**Paycor Stadium Southeast & Southwest VT Escalator Towers
Bid Package 2: Steel, Demo & Concrete
ITB#033-26
Addendum 3**

May 6, 2026

SECTOR 9
2
S-301
FRAMING ELEVATION
1/8" = 1'-0"

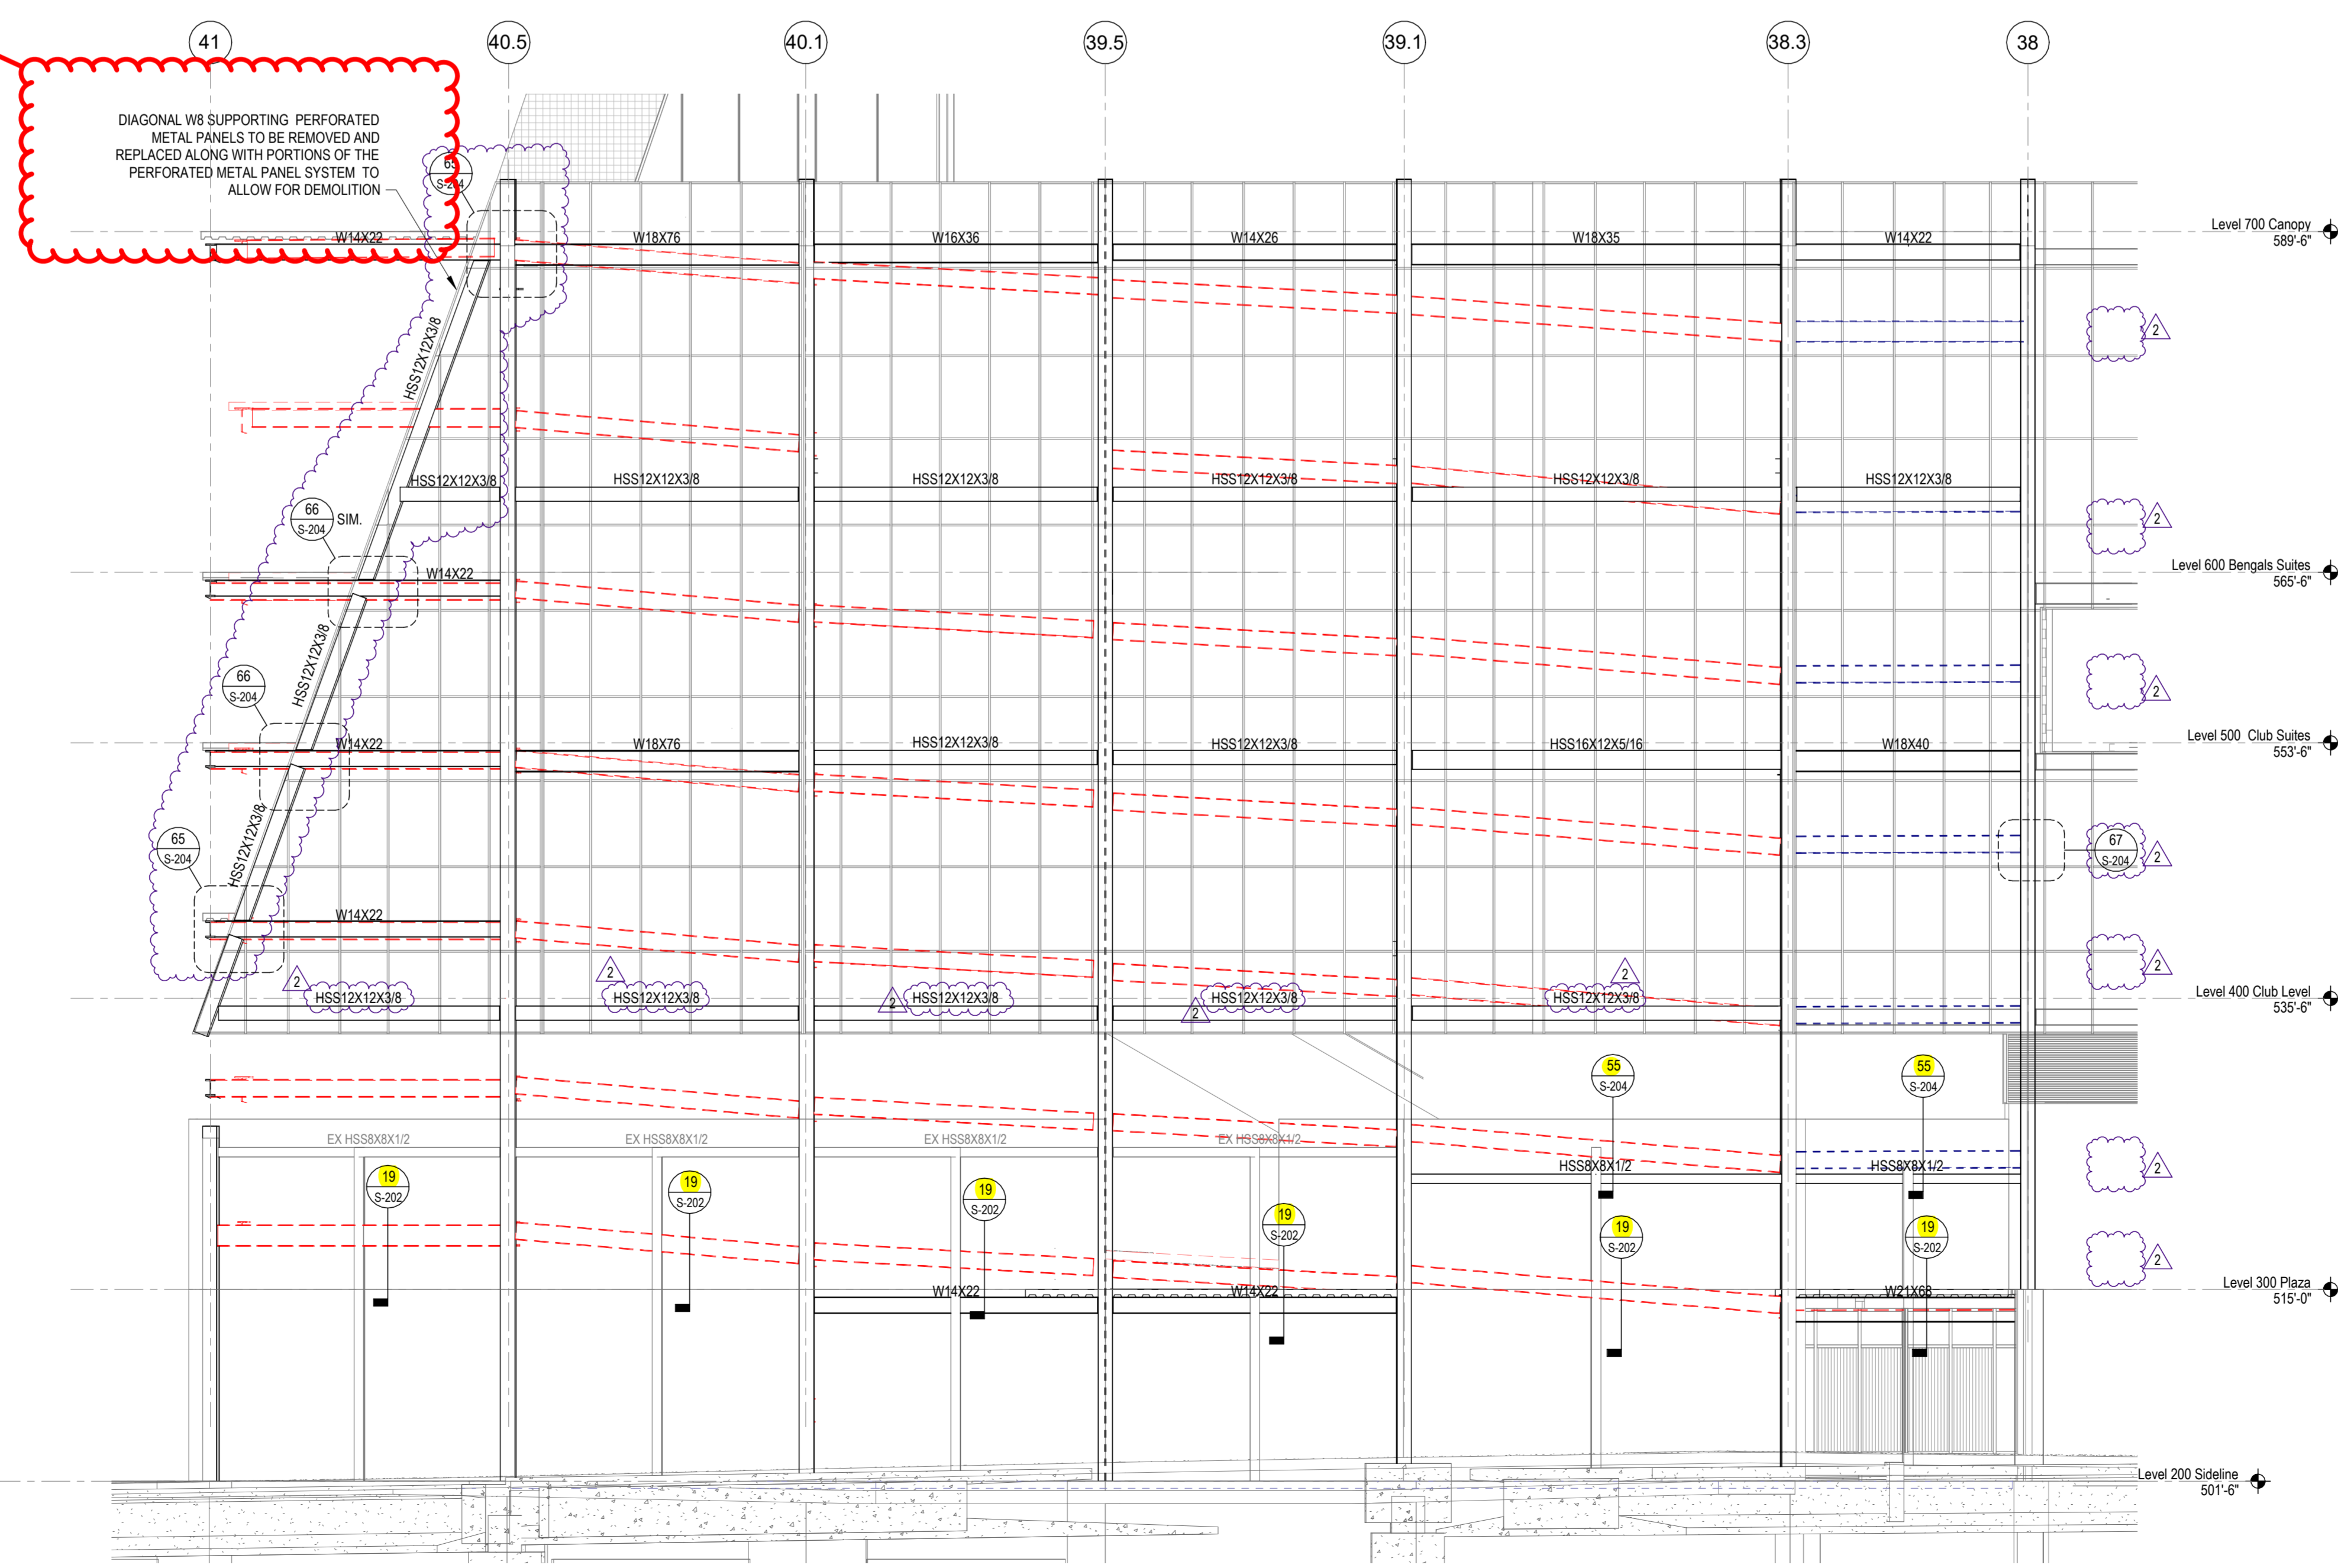
intent here is to show all items / steel to be able to make the precast to be demolished during the off season to be completed during the on season
IE install steel to be ready for demo during the on season so that demo can commence quickly once off season starts

East Shoring & Crane Pad Areas

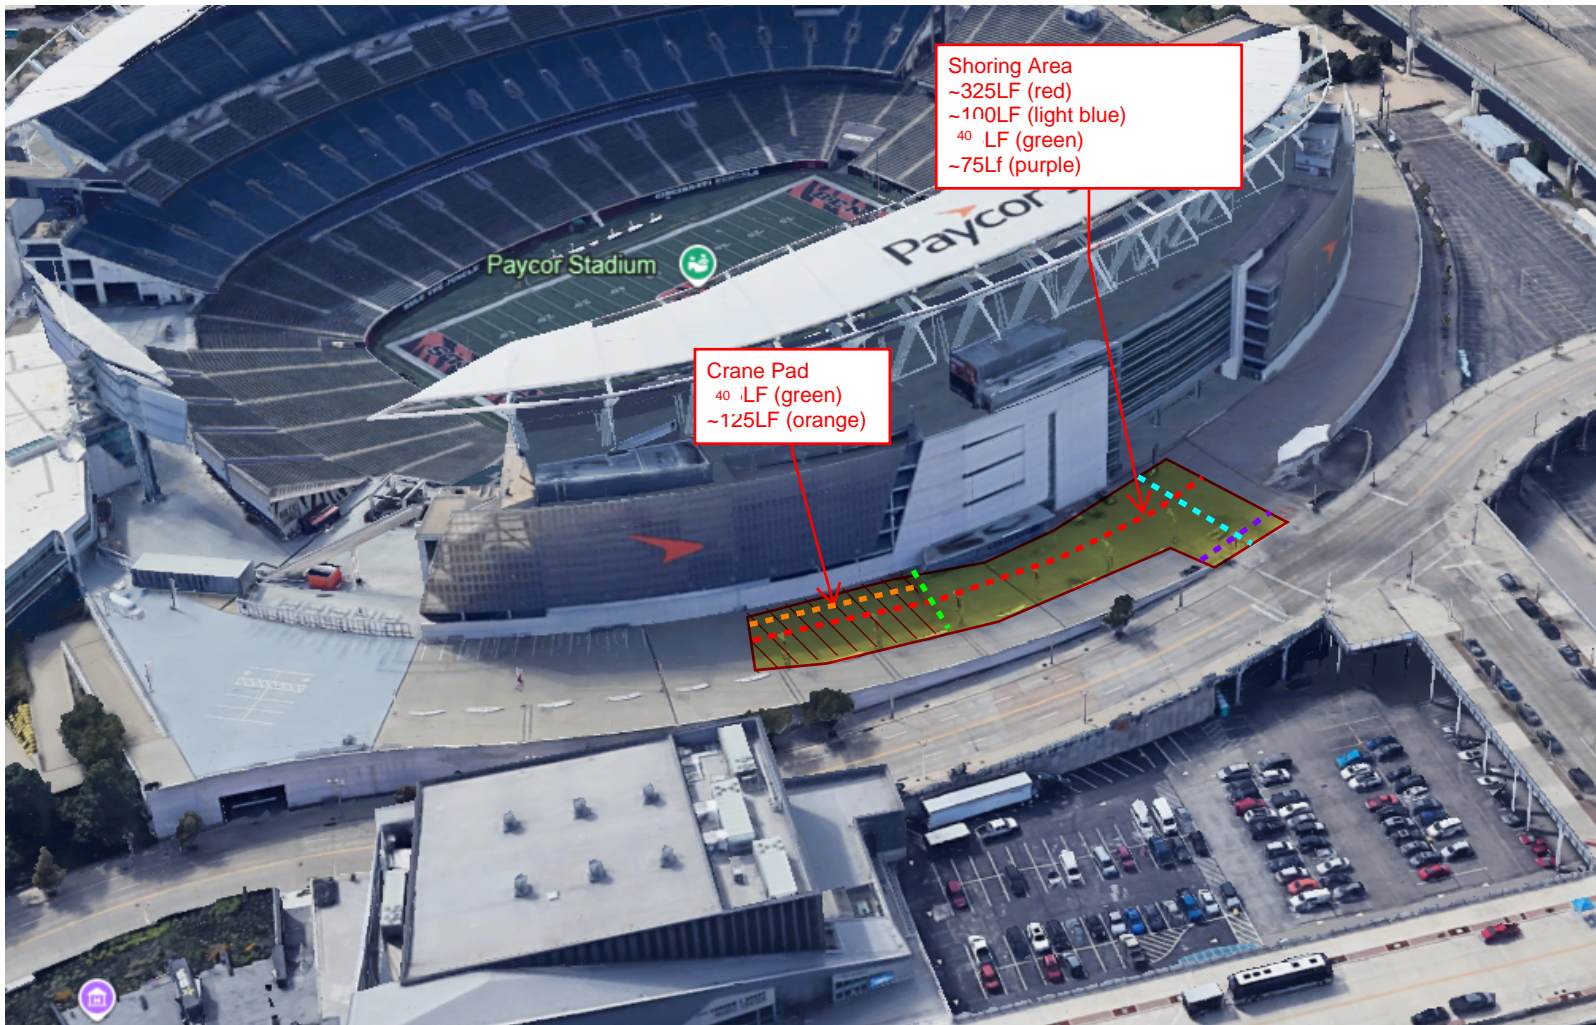
Crane pad width and shoring route width revised from 75'-0" to 40'-0"
